# The Europa

717 Dexter Avenue North

DESIGN EVOLUTION

**OPTION 3**

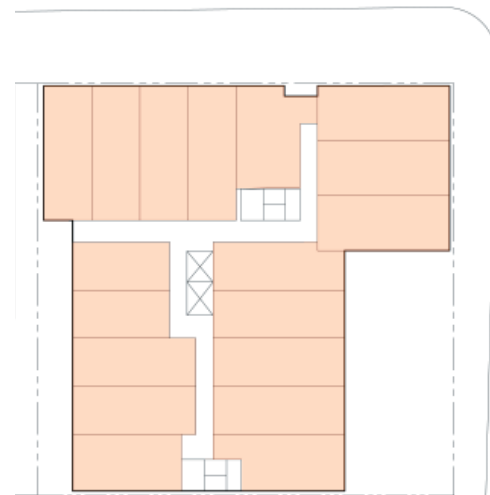
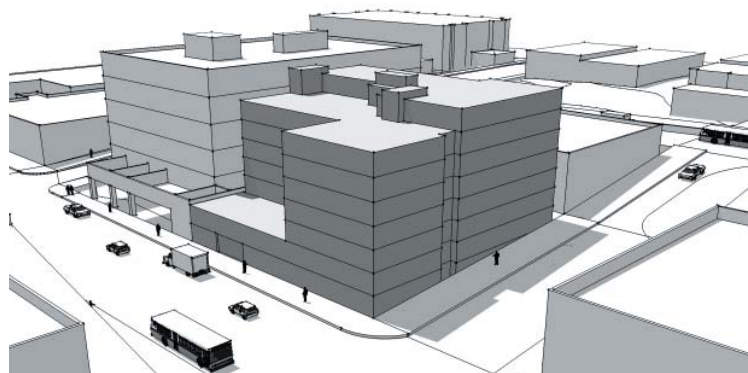
Retail base strong, needs add'l enhancement at pedestrian level  
Upper level "L" massing is architecturally strongest of all options  
Massing respectful of south neighbor at corner but large blank wall is concern to be addressed

**PREFERRED OPTION**

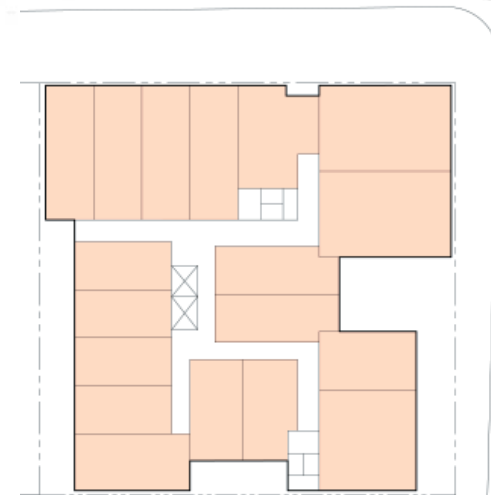
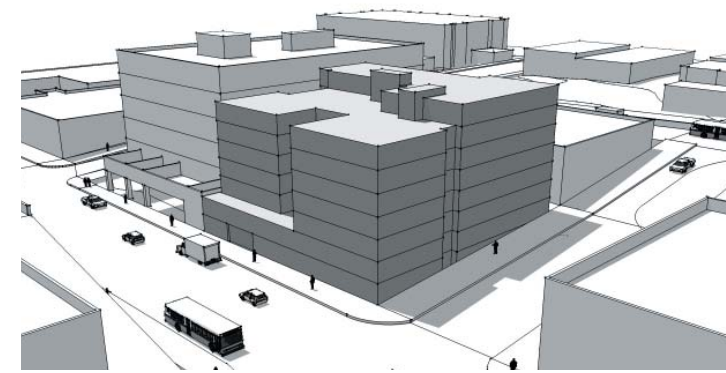
Retail base strong, needs add'l enhancement at pedestrian level  
Upper level massing is strong but bulkier than #3

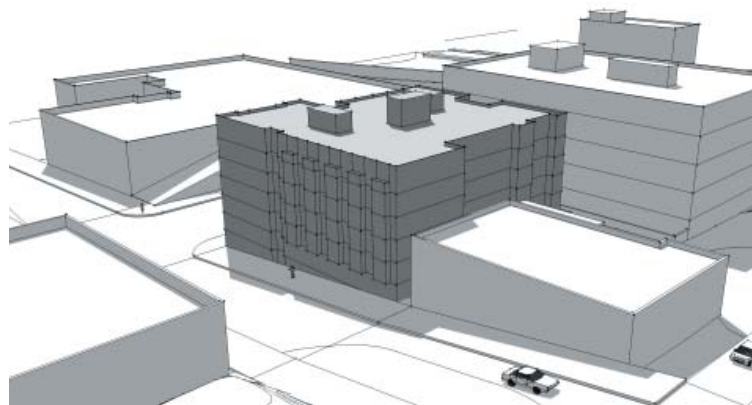
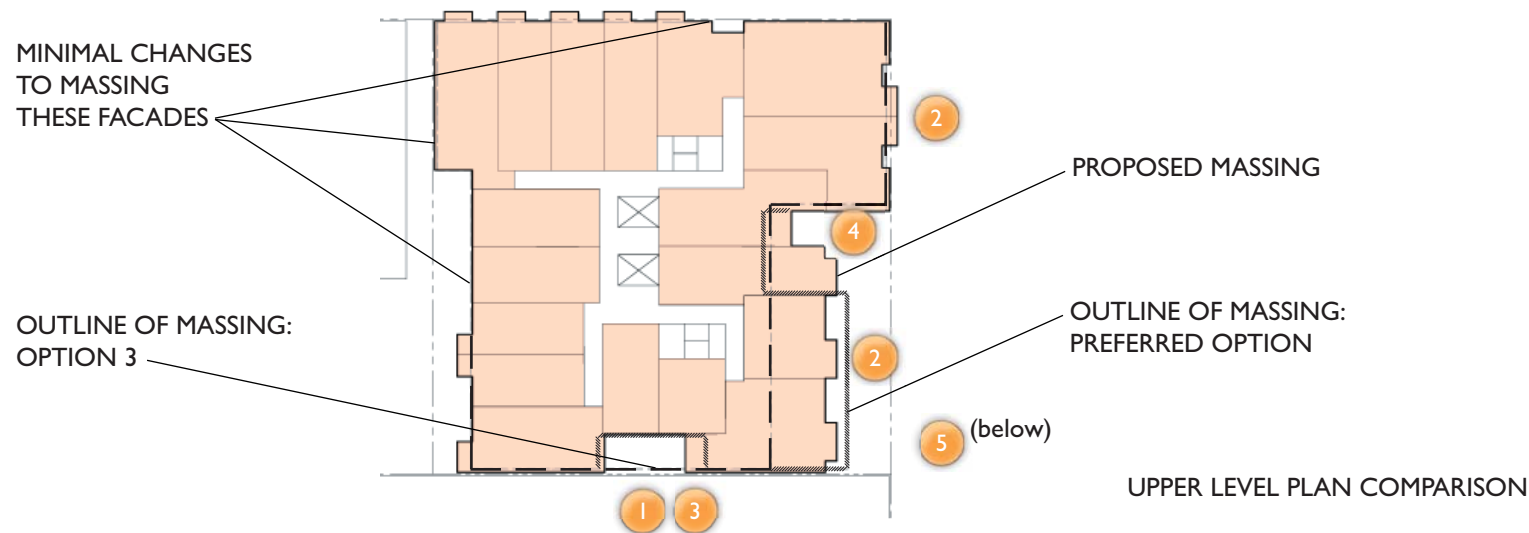
The DRB noted aspects of both Options 3 and Preferred that were desirable in the final design proposal. We took away from the meeting a similar understanding that while the Preferred Option had worthwhile upperstory massing, Option 3 had the simplest, most architecturally preferred massing. Further, the retail level along Dexter should if possible consolidate all retail into one strip and relocate the driveway entrance to the southeast corner of the project. We understood that the DRB identified the relocation of the driveway and retail consolidation as a high priority, while maintaining a clean architectural massing as shown in Option 3 was a preference.

The proposed project represents a combination of both Options 3 and Preferred in response to the comments and guidance given at the August 5th, 2009 DRB meeting. The relocation of the driveway to the south, while successful in consolidating the retail, incurred substantial internal organization challenges due to the requirements for discharge of an interior exit stairway. Upon final location of the stair within the typical residential floor plate, the floor plan schematic substantially changed. A hybrid version which combined aspects of both Options 3 and Preferred was therefore required to both achieve the development objectives as well as mitigating impacts to the existing office building to the south. No substantial changes were required for facades on the west or north as a result of these organizational challenges.

1. South-facing courtyard (Preferred Option) was retained to maintain unit count. Additional fenestration and deck railings were utilized to add visual interest and maximize daylighting.

2. Bay window and deck massing on east-facing facades (Option 3) were retained to emphasize residential unit separation and provide massing modulation.

3. Building massing for the southern half of the building on the east façade was increased to the east in excess of Option 3, but not as extensively as shown in the Preferred Option. Bay windows (described above) were utilized in lieu of additional substantial massing as shown in the Preferred Option, thereby mitigating impact to the office building to the south.

4. Building mass separation, while reduced in MUP proposal, was maintained (Preferred Option) at east-facing façade.
5. Ground-level retail modulation was increased from both options 3 and Preferred by utilizing live-work units in place of approx. 40% of the newly consolidated retail, increasing pedestrian scale elements and providing additional landscaping along the sidewalk.
